**STAFF REPORT: OCTOBER 11, 2023 MEETING**

**APPLICATION NUMBER: HDC2023-00055**

**ADDRESS: 9120 DWIGHT**

**SCOPE: REPLACE WOOD WINDOWS WITH COMPOSITE WINDOWS**

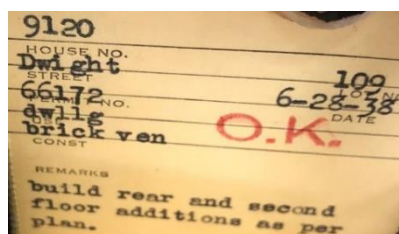
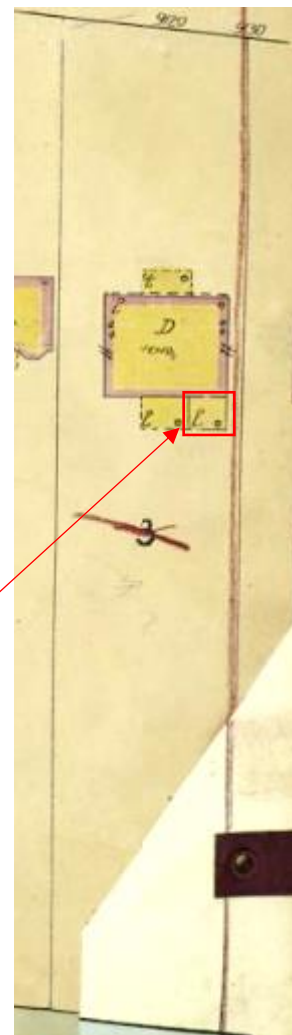
- One Palladian-style dormer – one 4-over-1 double-hung unit in each dormer opening.
- Three first-floor openings – reverse cottage-style window divided into a 2/3-over-1/3 proportion, no grille pattern; custom lower wood panel.
- Sliding (full glass in each panel) door.

Applicant photos.

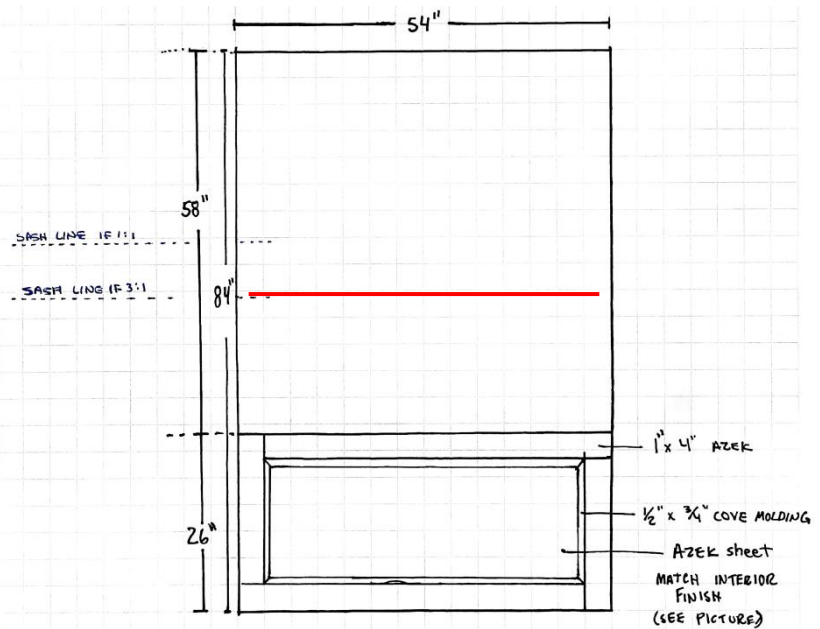
- It is staff's opinion that the large openings at the first floor rear elevation likely had French doors that led to the rear yard patio, but there is no visual confirmation on what had been in these openings. The current fixed glass windows are not historic nor character-defining features of the property.

- The applicant submitted the following mock-ups to give an idea on how the window openings numbered 101, 103, and 104, will be modified. The red line demonstrates the location of the meeting rail for the reverse cottage-style window. According to the window order, the cottage windows will not have a grille pattern in the top and bottom sash.

- It is staff's opinion that the proposed design for the exceptionally large openings at the rear of the house will be compatible with the historic character of the building.

- Staff received clarification that the exterior lower wall will receive the paneling design as shown below, which mimics the paneling in place on the interior walls. Staff asked for a more detailed mock-up to show the cottage window in place so its proportionality, in contrast to a double-hung window, can be assessed.

- A dimensioned drawing that clearly shows how the reverse cottage-style window will look within the newly sized opening, as well as clarification over the exterior detailing of the lower wall, will be submitted to staff for review.
- Should staff determine the reverse cottage-style window is not appropriate for these windows openings, a standard double-hung window (no grid pattern in the upper or lower sash) will be selected.
